The foundations, at the northern most point, for plot 34, are proposed to be ~3.68m above existing ground level: *see image right.*

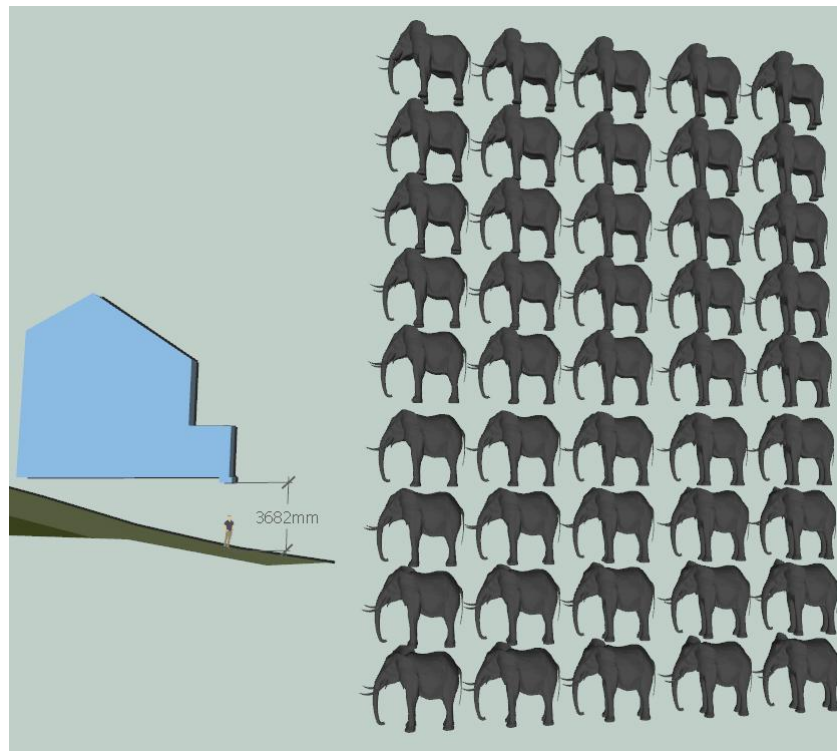
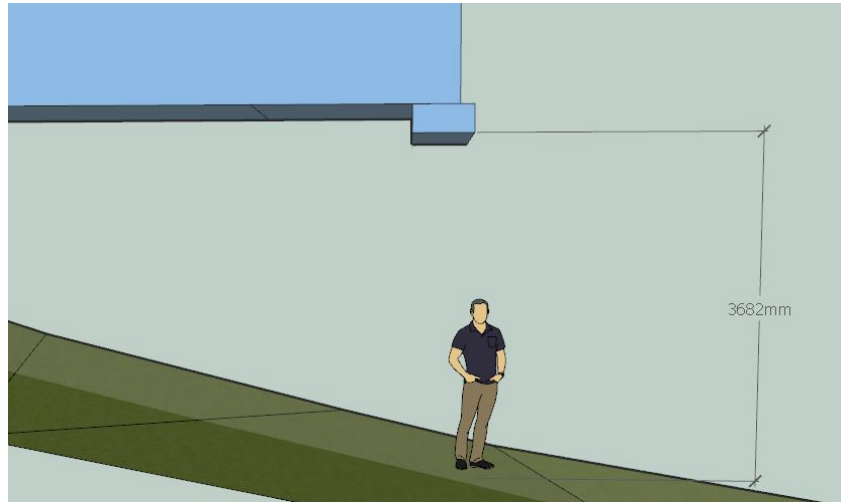
To achieve that, infill material would be needed.

A valid question is, how much infill material would be required?

Taking a conservative estimate, it would require approximately 276 metric tonnes of compacted soil.

For comparison, 276 metric tonnes roughly equates to 45 adult male elephants.

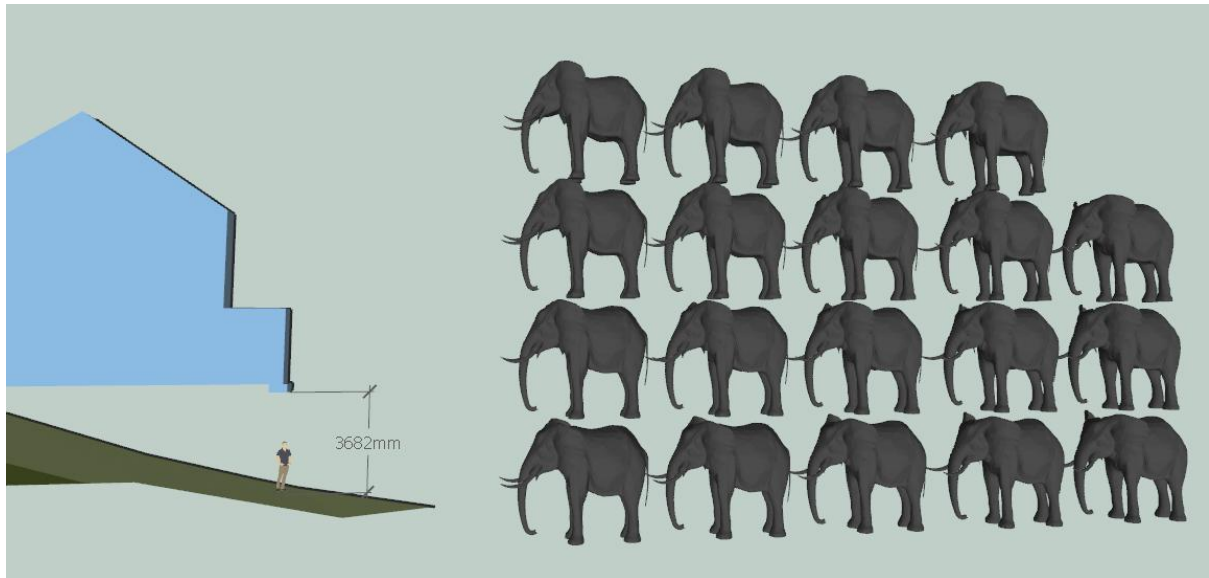
The terrace, proposed for the rear, would require infill too.

This would add the equivalent of circa. 15 more elephants.

Making a total of around 60 male elephants.

So, even though the applicant refers to dwellings following the contours, it's simply amazing just how much infill would be required to achieve that.

To my mind, following contours would not require very much infill at all, if any.

To my mind, requiring so much infill suggests the proposed dwellings are not suitable for where they are proposed.
